IN THE MATTER an Application by GTM
Developments Limited for
Resource Consent to demolish a
scheduled heritage structure and
to build and operate a
commercial building – 1 Irk
Street, Gore

SUBMITTER Foodstuffs South Island Limited

STATEMENT OF EVIDENCE OF JOSEPH PAUL DURDIN

THURSDAY, 16 JUNE 2016

Figure E: Anticipated Change in Unrestricted On-Street Parking Demand

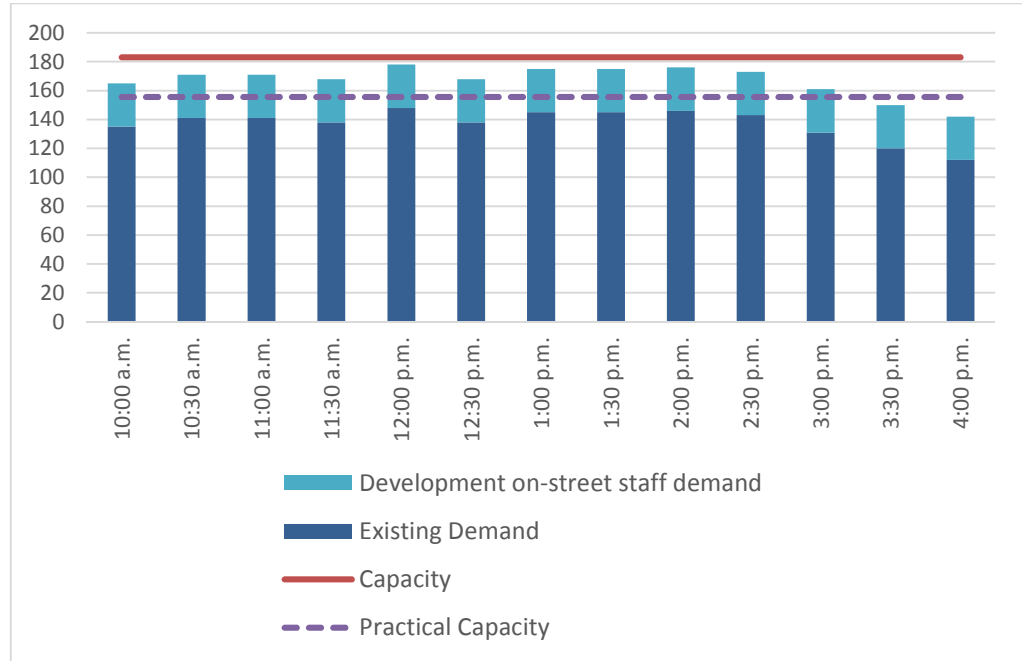
6.4 **Figure E** shows that the projected demand for unrestricted on-street car parking would be likely to exceed practical capacity for the majority of the day.

6.5 This will manifest in longer-term commuter parking extending beyond the survey area, potentially to streets outside the town centre that have a residential function. It is also probable that some shorter-term parking will be occupied by longer-term parkers, which the MWH parking assessment notes is already occurring. This behaviour is likely to be exacerbated if there is an under supply of unrestricted car parking spaces, resulting in greater utilisation of time restricted parking spaces and other convenient parking areas, such as the New World car park.

- 7.25 My Figure E shows that if the development was to go ahead in its current form (subject to on-site layout modifications) then unrestricted on-street parking in the wider area would exceed practical capacity for the majority of the day.

Figure F: Anticipated Change in Time Restricted / Metered Parking Demand

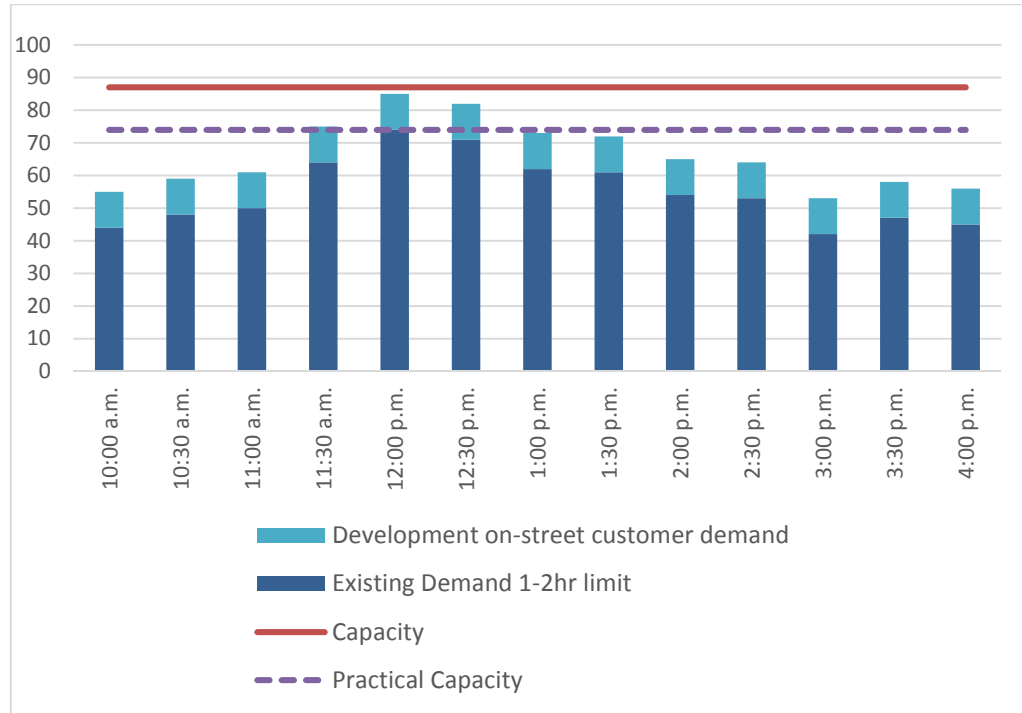
6.6 **Figure F** shows that the projected demand for shorter-term time restricted and metered parking could generally be accommodated below practical capacity, except for the busy period between 12pm and 1pm.
